ADDENDUM NO. 1

Additions & Renovations to Pleasant Run Elementary School
1800 North Franklin Road
Indianapolis, IN 46219

PROJECT: PLEASANT RUN ELEMENTARY SCHOOL RENOVATION & ADDITION

PROJECT NO: 2020061

DRAWING NUMBER
A401

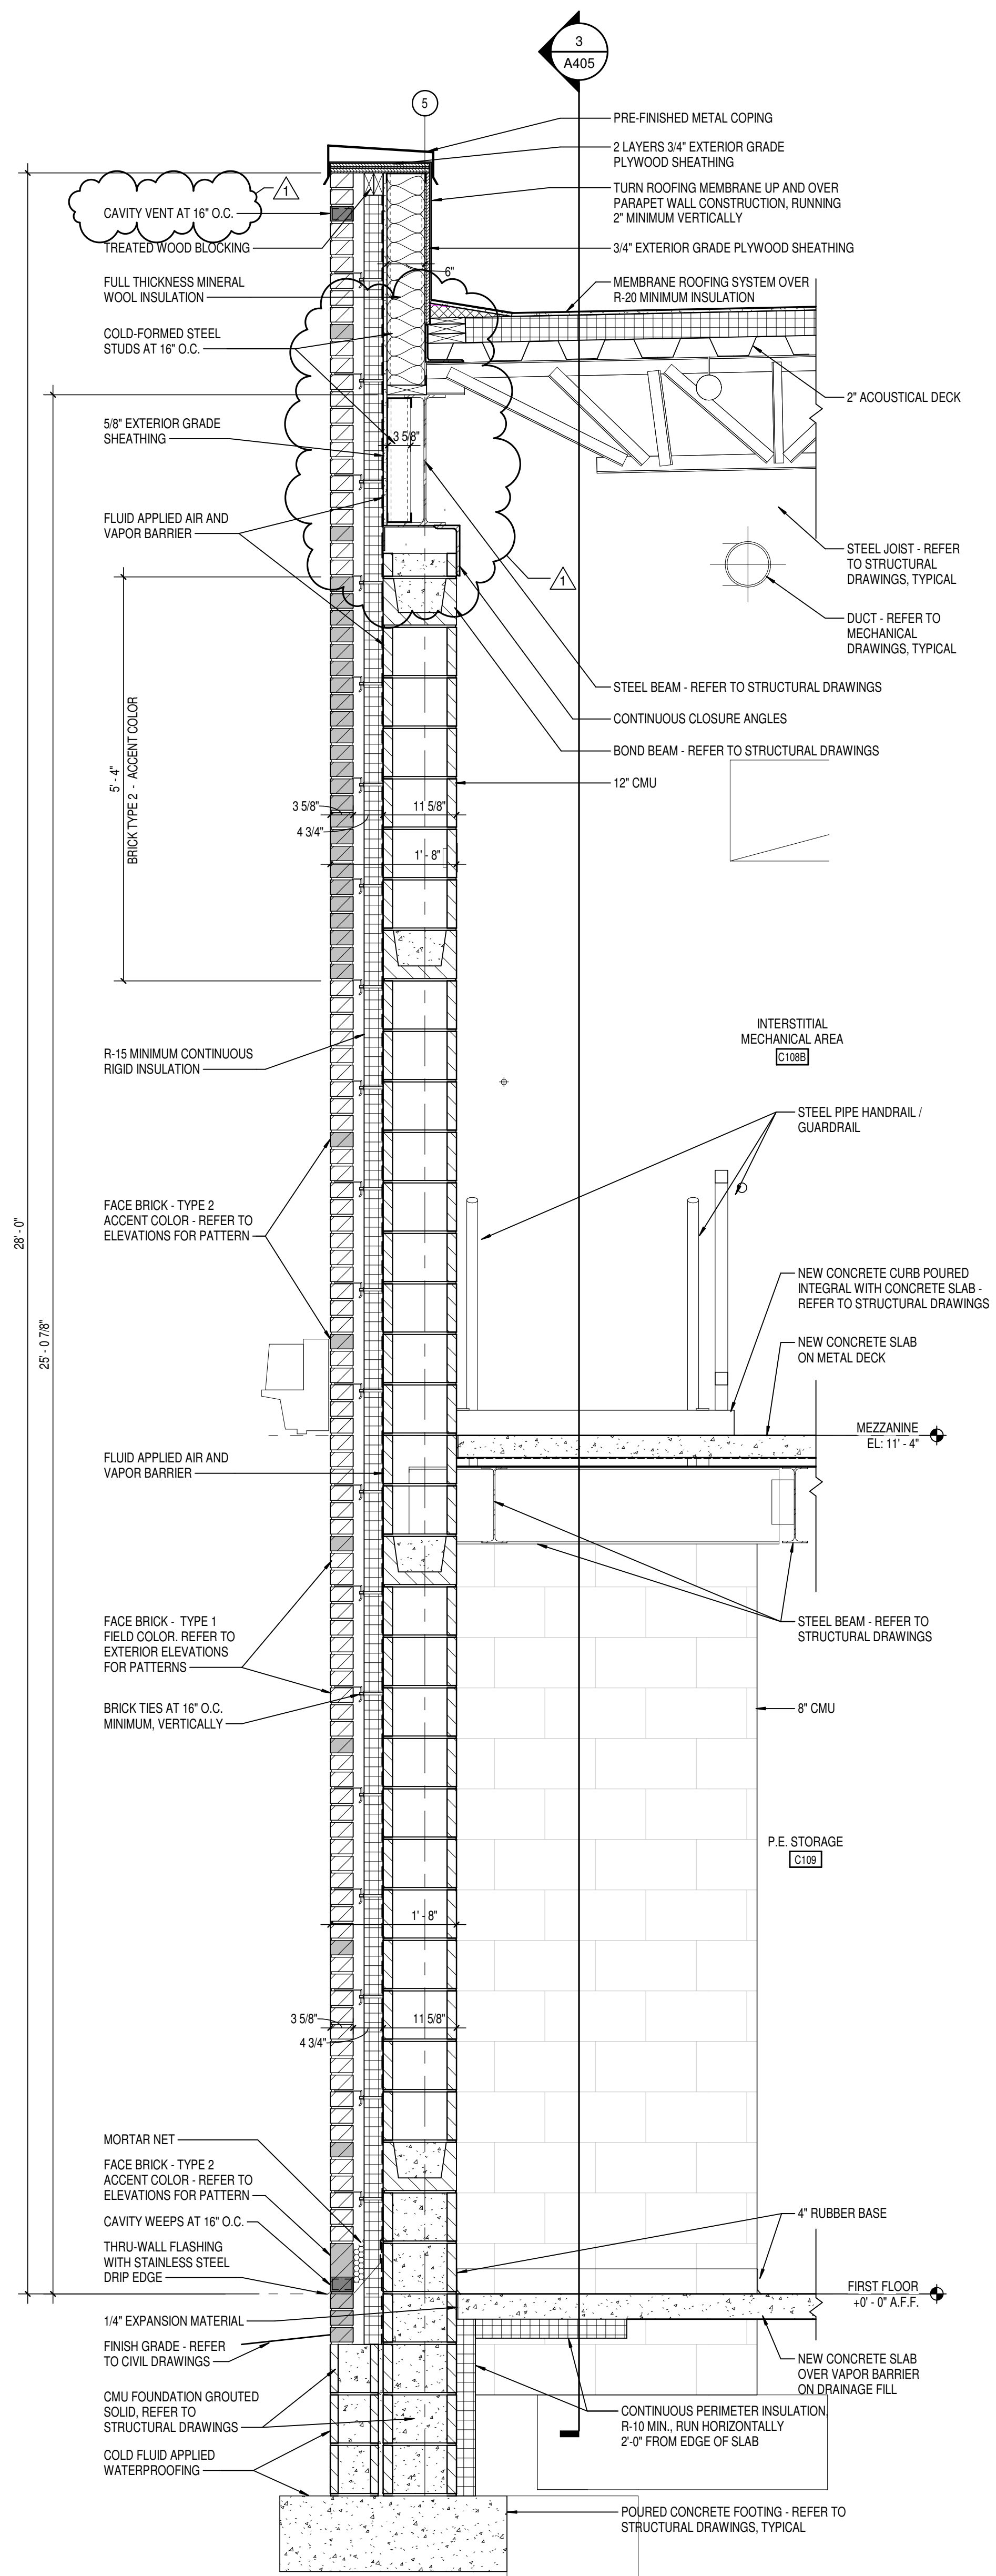
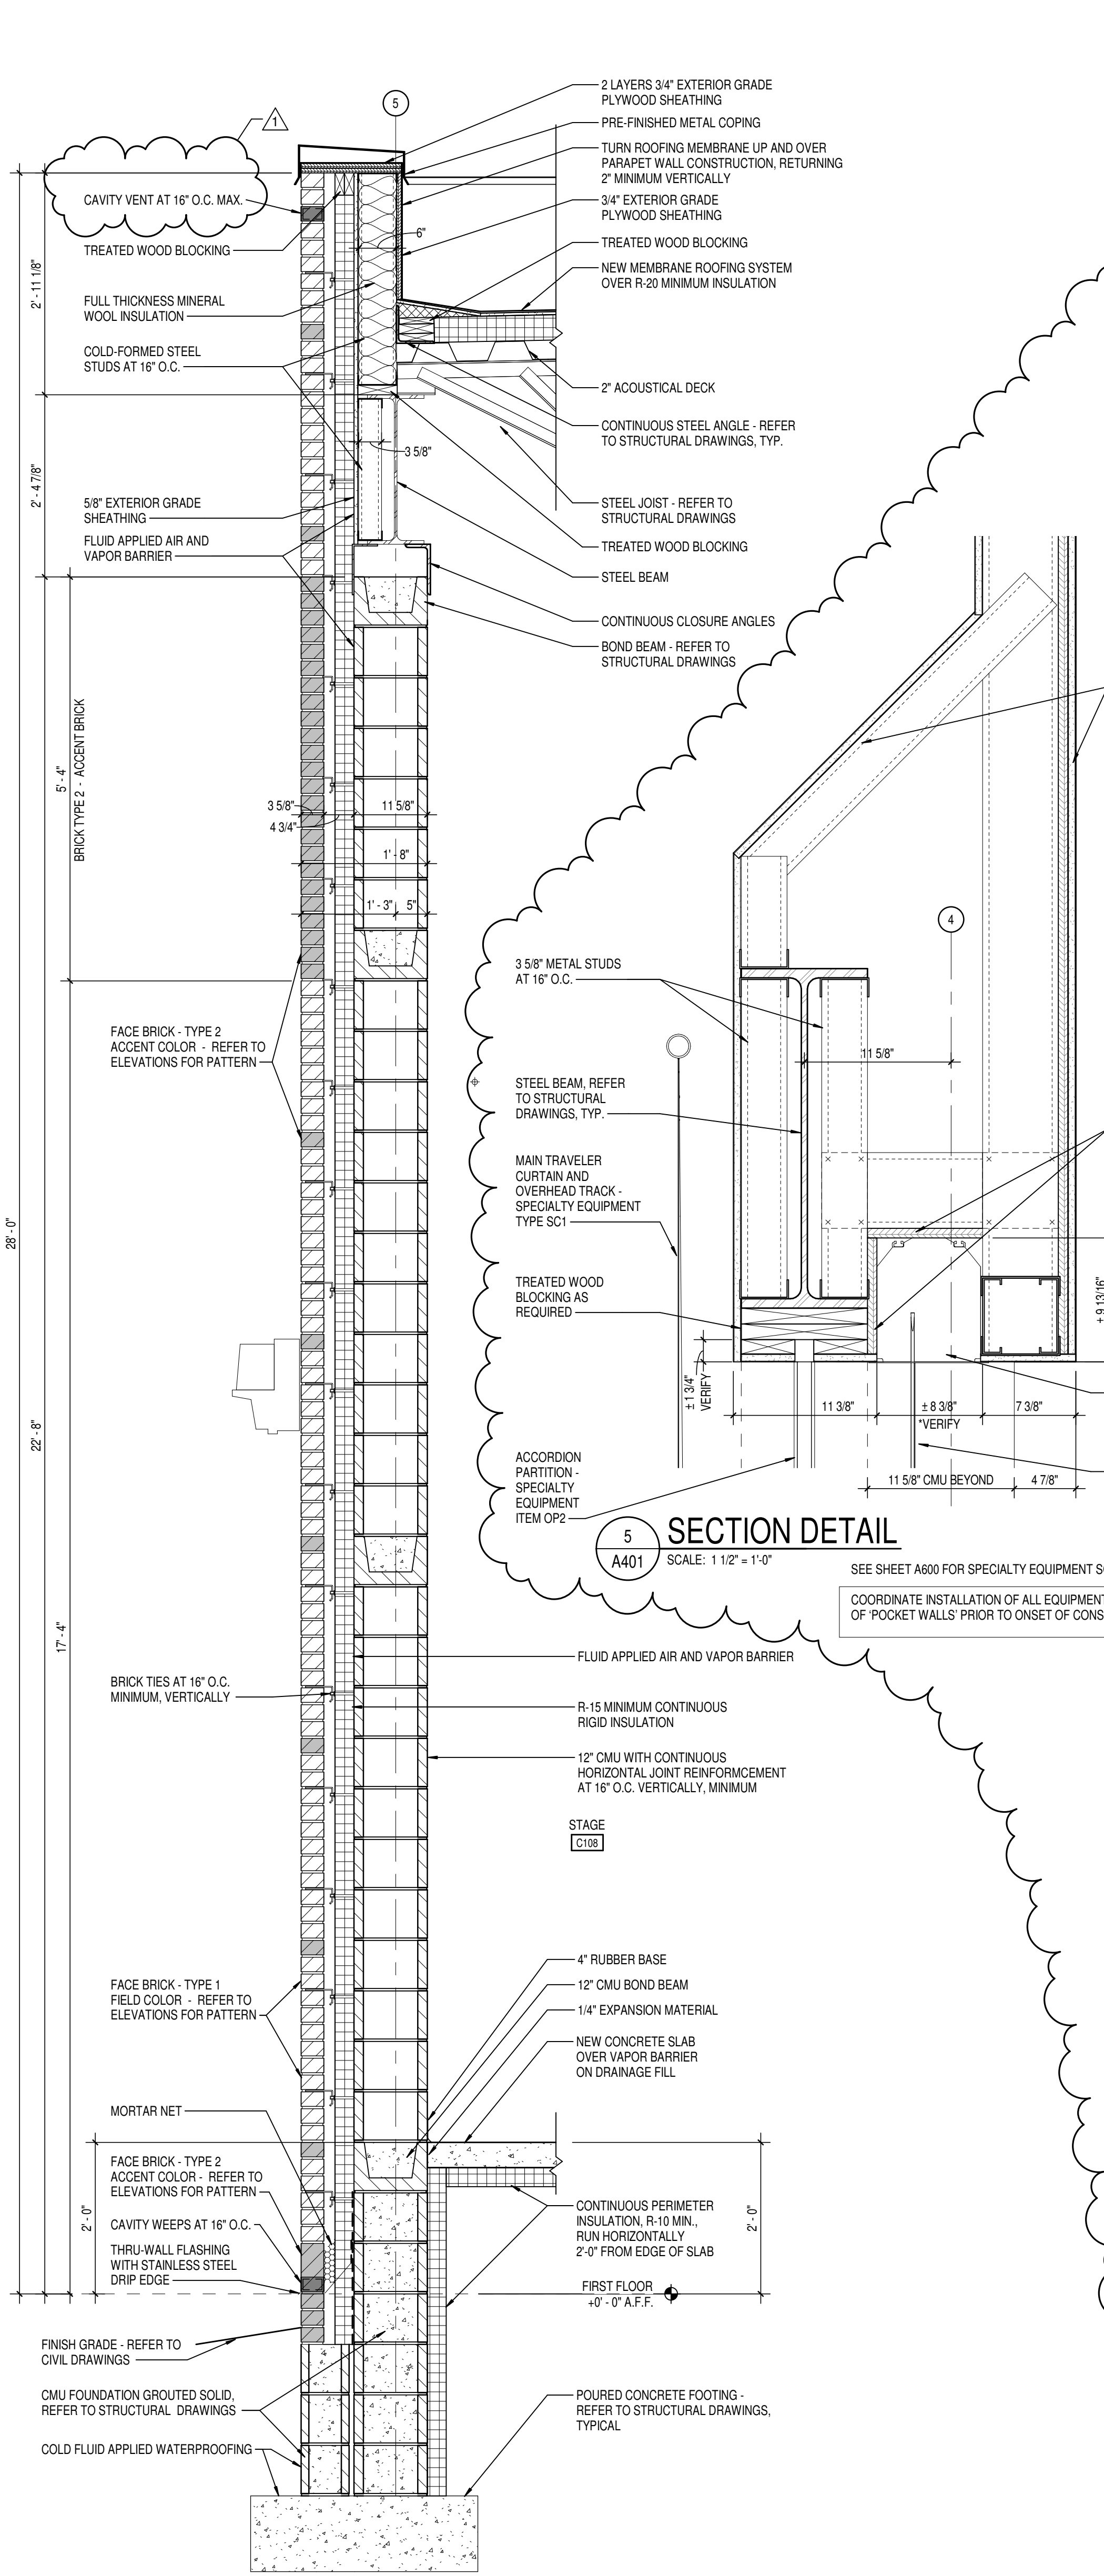
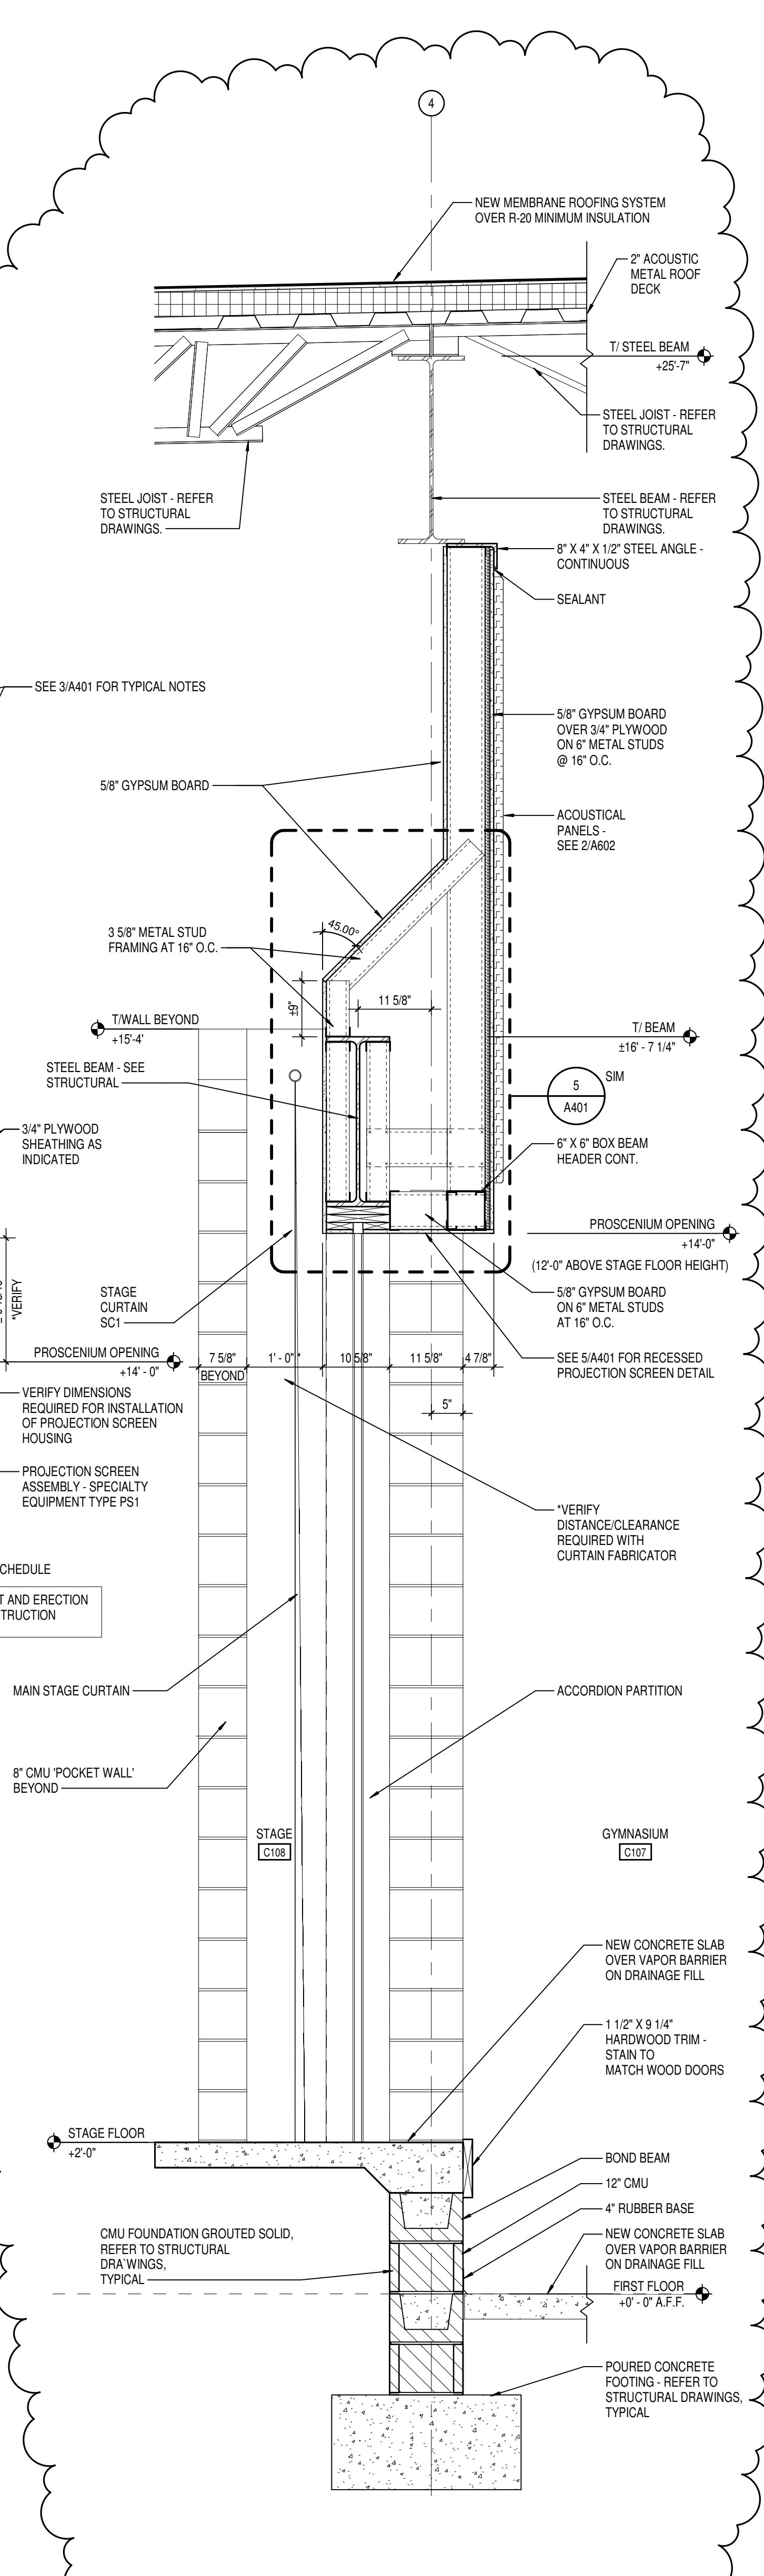
- A. At all WALL SECTIONS, replace any reference to Cavity Weeps and/or Vents to "16" O.C. MAX." in lieu of either note "24" O.C. MAX." or "2'-0" O.C. MAX.
